ADDENDUM NO. 1

Blackwater Golf Club Lift Station and Force Main Project

Date: January 24, 2021

Jacobs Project No.: D3553000

ELECTRICAL
SITE PLAN

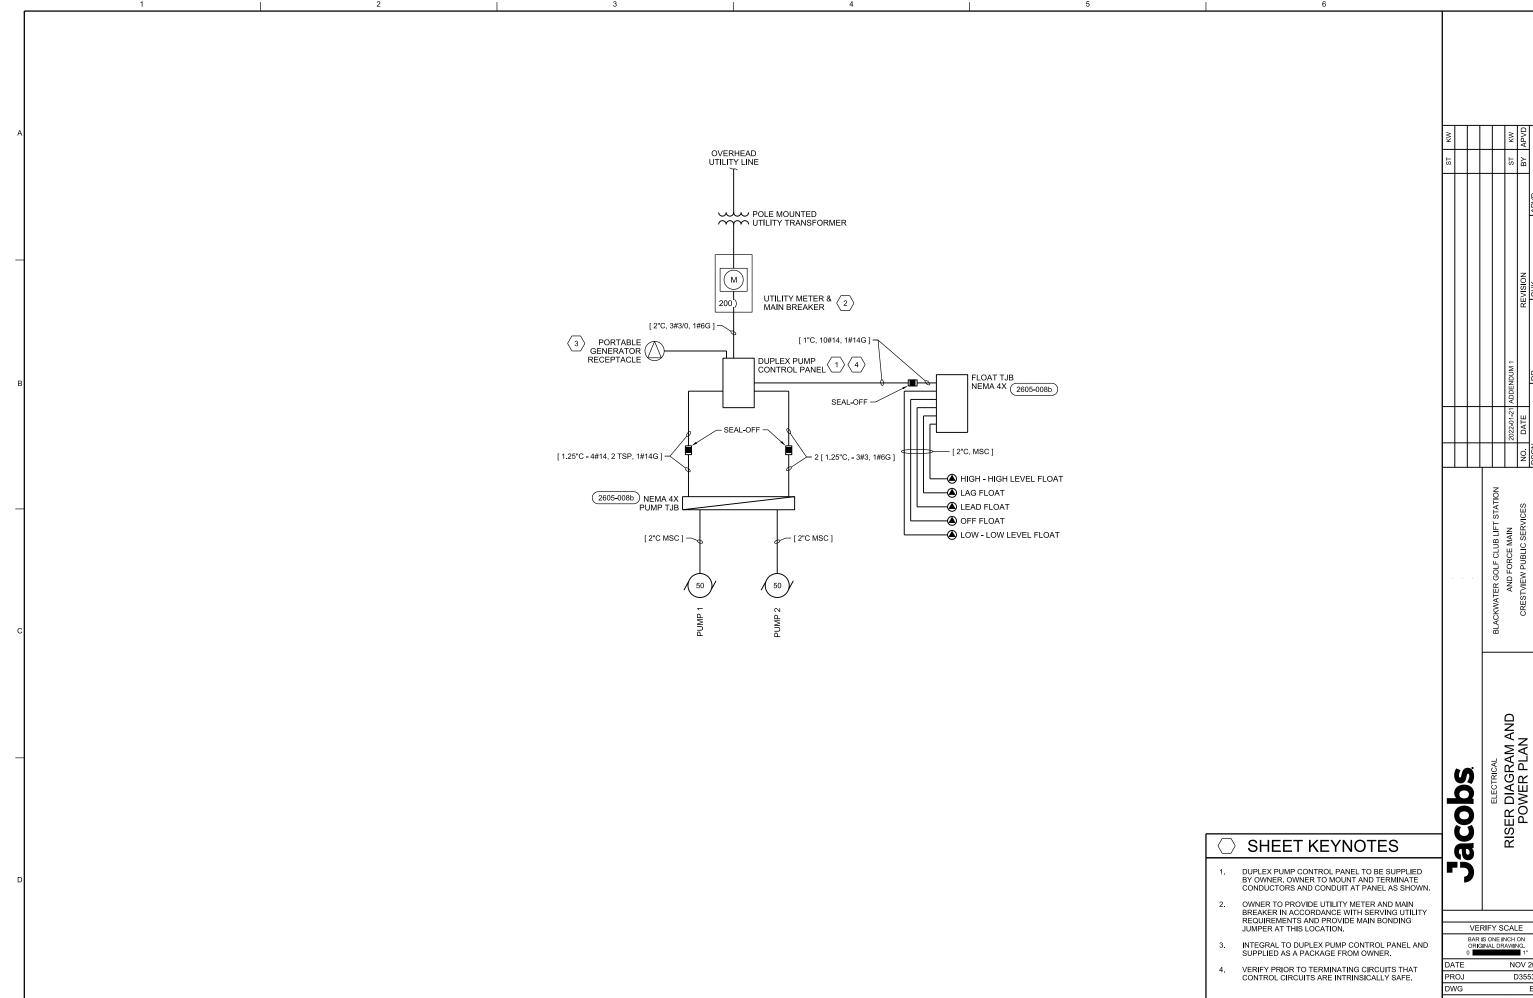
- a. DELETE Drawing E-001 and replace in its' entirety with the attached revised Drawing E-001.
- b. DELETE Drawing E-201 and replace in its' entirety with the attached revised Drawing E-201.

1. CONTRACTOR TO COORDINATE NEW ELECTRICAL SERVICE WITH CITY STAFF AND SERVING UTILITY.

OVERHEAD LINE SHALL BE PROVIDED BY SERVING UTILITY AND OWNER IS RESPONSIBLE FOR PROVIDING POLE AND CONDUIT TO TOP OF POLE FROM METER ENCLOSURE. SERVING UTILITY WILL LOCATE AND PROVIDE 3-PHASE TRANSFORMERS.

2. OWNER TO SUPPLY AND INSTALL ALL ELECTRICAL EQUIPMENT, CONDUITS AND CIRCUITS. CONTRACTOR IS RESPONSIBLE FOR CONSTRUCTING CONCRETE EQUIPMENT PADS.
